Technical Service Bulletin: TSB200111

Eliminator™ Filter and Eliminator™ Hydraulic Motor

This document announces a new hydraulic motor for the Eliminator. This includes changes internally to the motor to increase its capability.

Figure 1, Hydraulic Motor

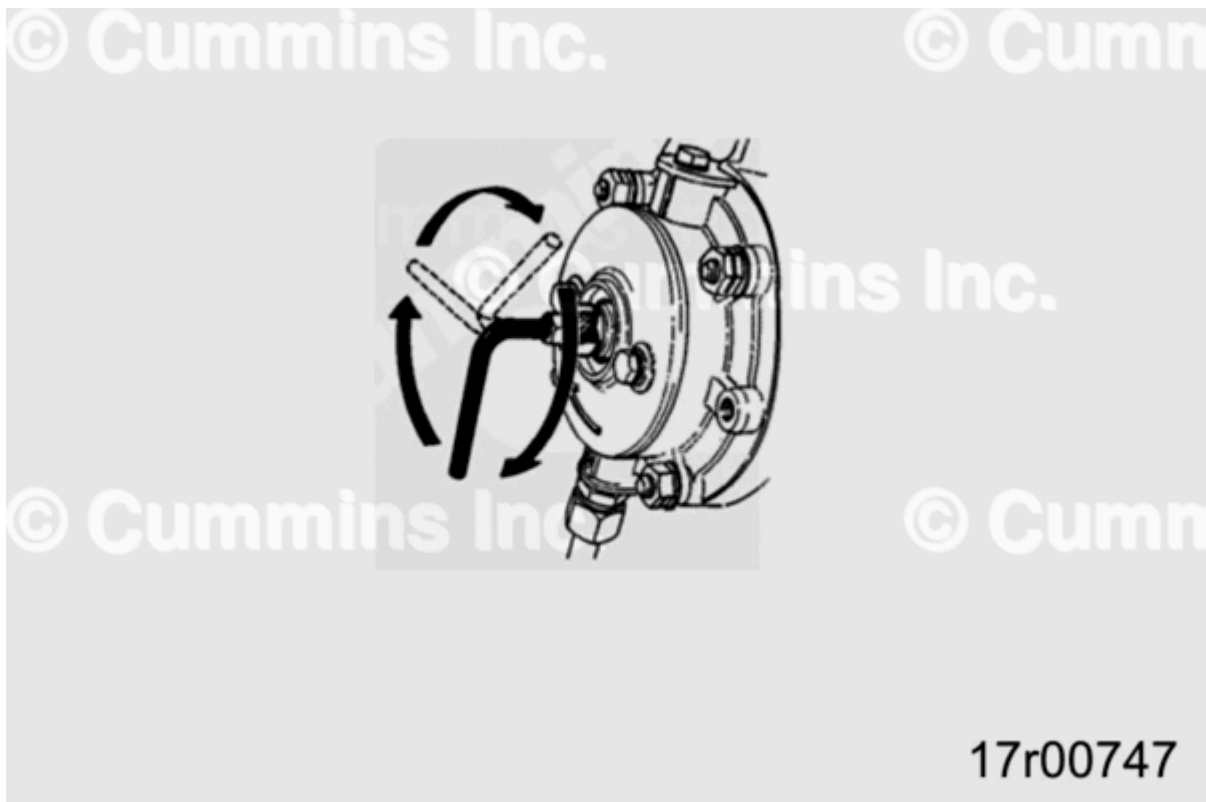
Check the function of the hydraulic motor. Make a note of the number of minutes it takes to do one revolution.

The following are given as a guide for a normal operating condition:

- Engine at idle: 10 minutes maximum

- Engine at max RPM: 5 minutes maximum

Note : If the operating indicator does **not** rotate, or the time for one revolution is more than indicated above, check the pressure drop and make a note of the value. Under normal operating conditions, the value **must not** exceed 12 psi.

If the motor is found to not function as intended, it **must** be replaced with a new or reconditioned part.

Figure 2, Eliminator Motor "CK" Marking Location (Previous version shown "CJ" for this example)

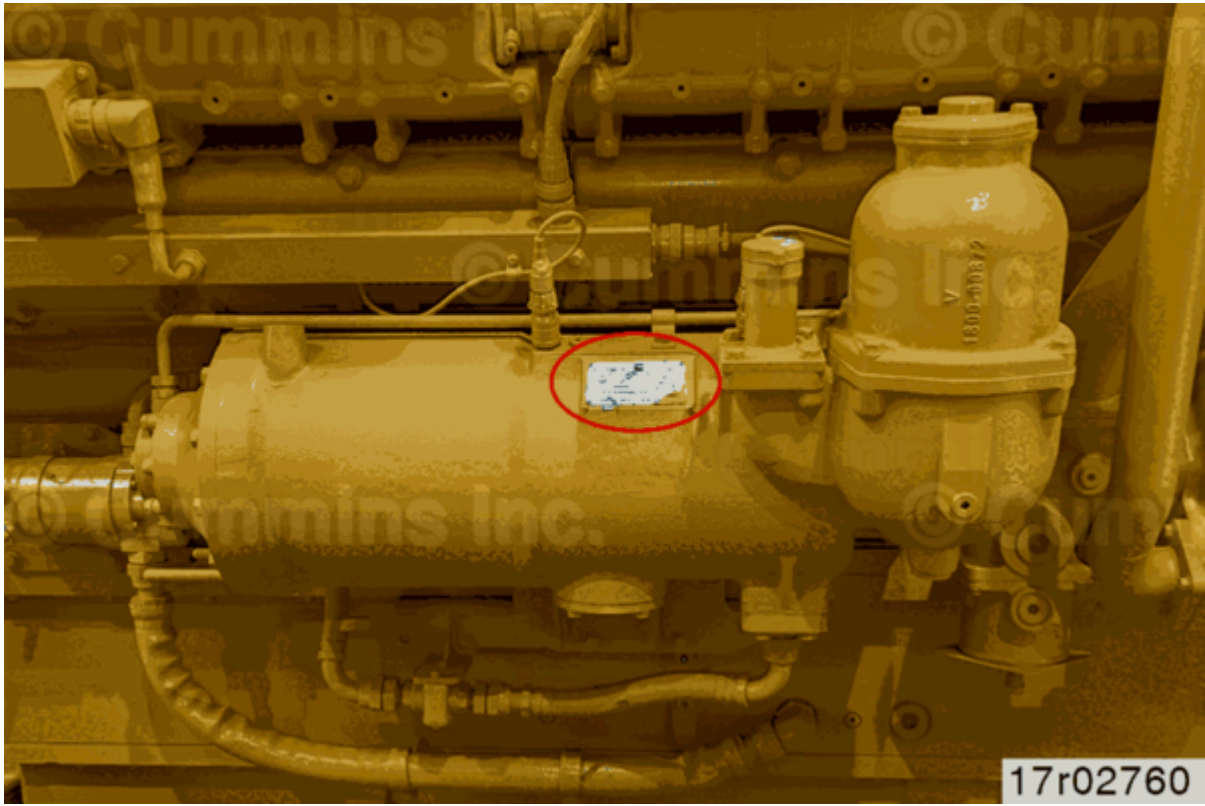
The two motors are only distinguishable by their stamped part numbers. The part numbers are marked on the motor and is their **only** identifier. The stamped designation "CK" identifies the latest part number motor. The "CK" stamping is only visible when the motor is removed. See Figure 2. The Cummins part number is not stamped onto the motor.
